Combined License Application Review North Anna 3 (NA3)

**Safety Panel
March 23, 2017**

Safety Panel Topics

North Anna Site and Mineral, Virginia Earthquake

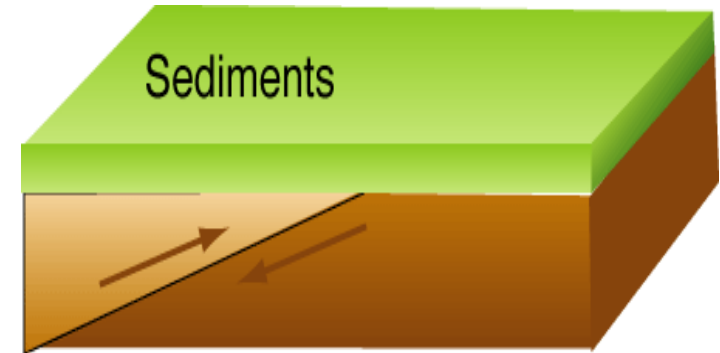
Mechanism of the earthquake was blind reverse fault with hypocenter located at the depth of 5 miles.

Variance from ESP

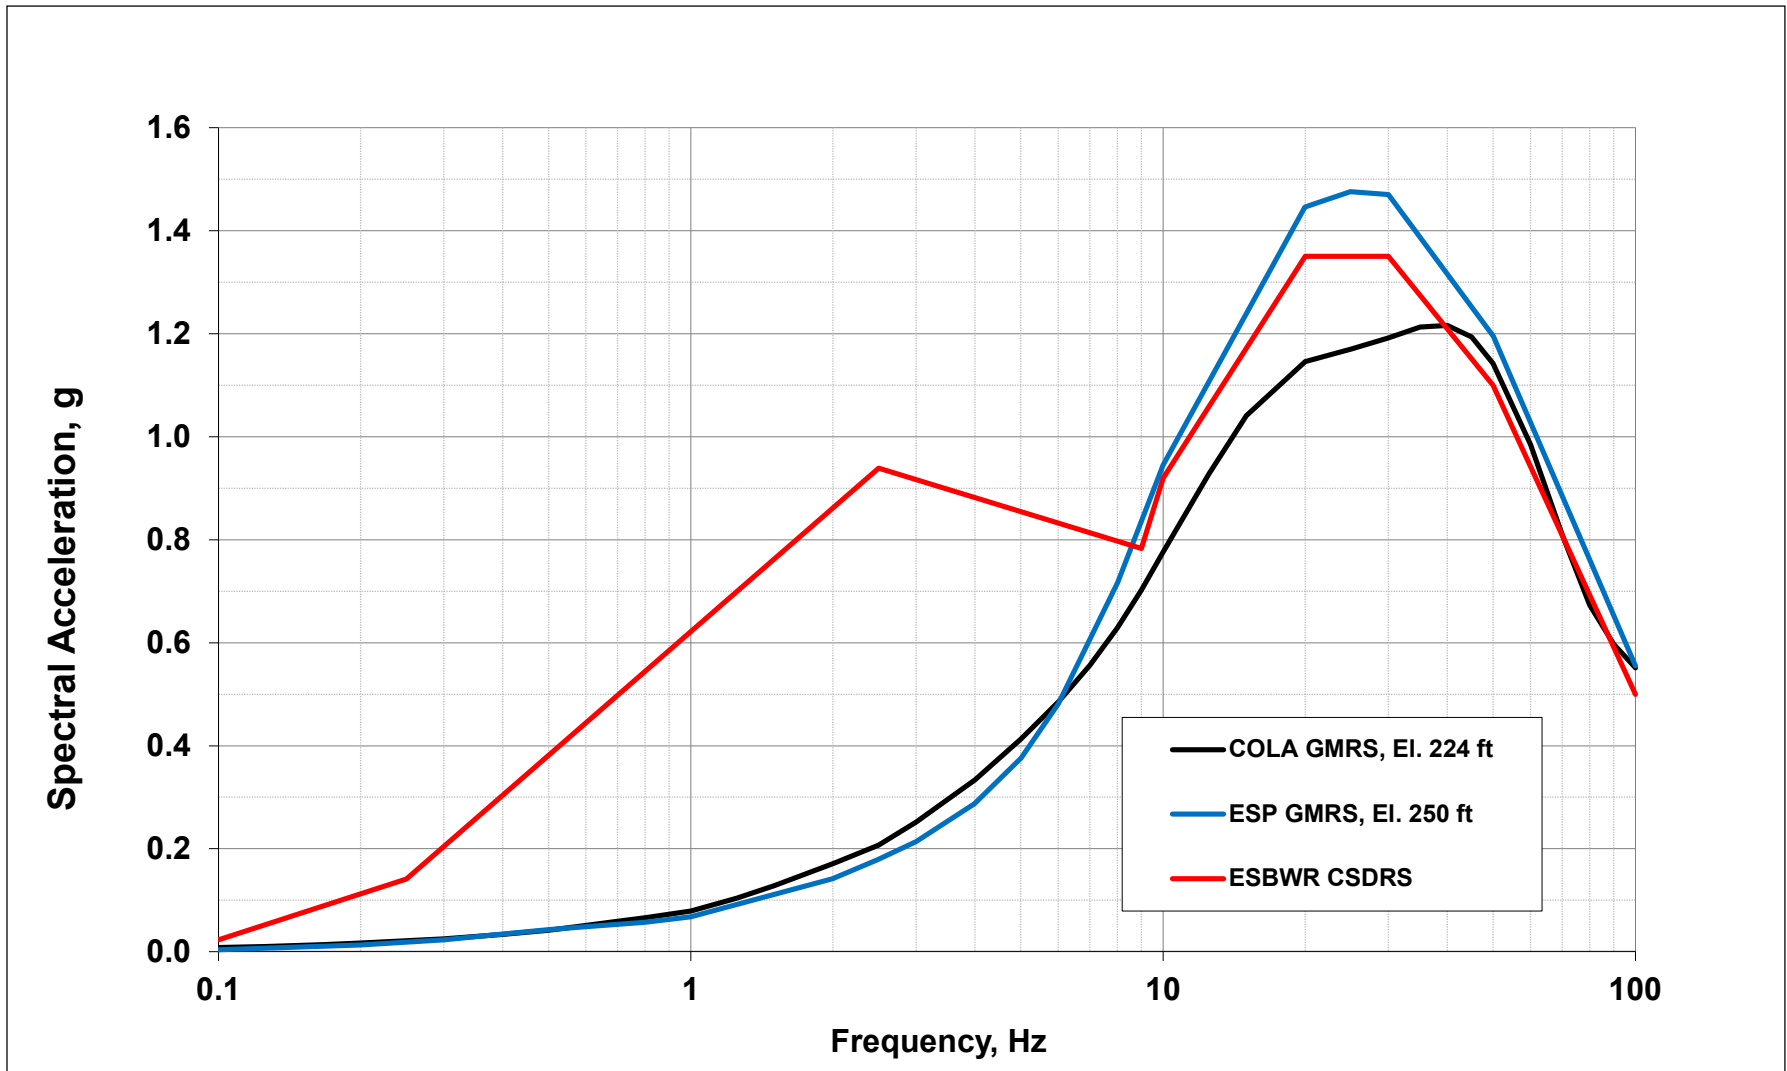
**Variance NA3 (2013) ESP VAR 2.0-4:
The applicant took a variance from
values in the ESP because of:**

- Different building elevations than assumed in ESP**
- New CEUS-SSC model (NUREG-2115 2012) and new Ground Motion Model (EPRI, 2013)**
- Mineral, Virginia earthquake**

NA3 GMRS and ESBWR CSDRS

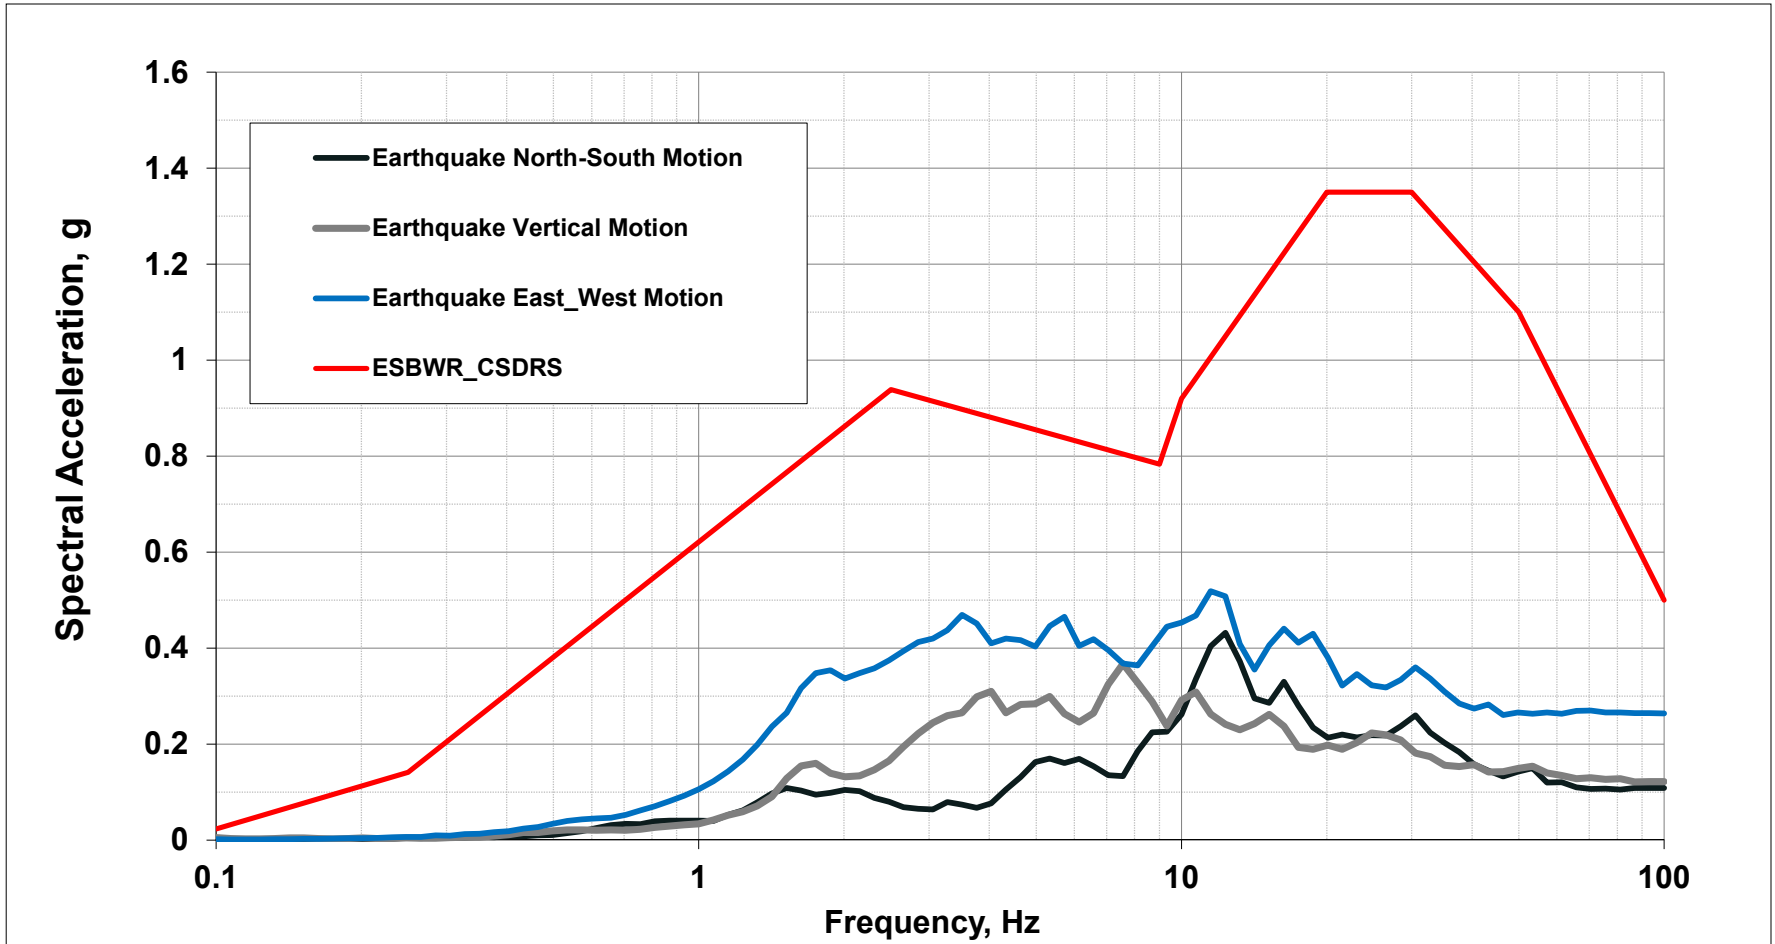
- **Staff performed independent PSHA based on updated models**
- **Staff confirmed that the site-specific COLA ground motion response spectra (GMRS) envelope the North Anna 3 site variations (FSER Chapter 2 Section 2.5.2)**

- **The site-specific GMRS adequately represents the seismic hazard at the NA3 site and meets the relevant regulatory requirements provided in 10 CFR Part 52 and 10 CFR Part 100**
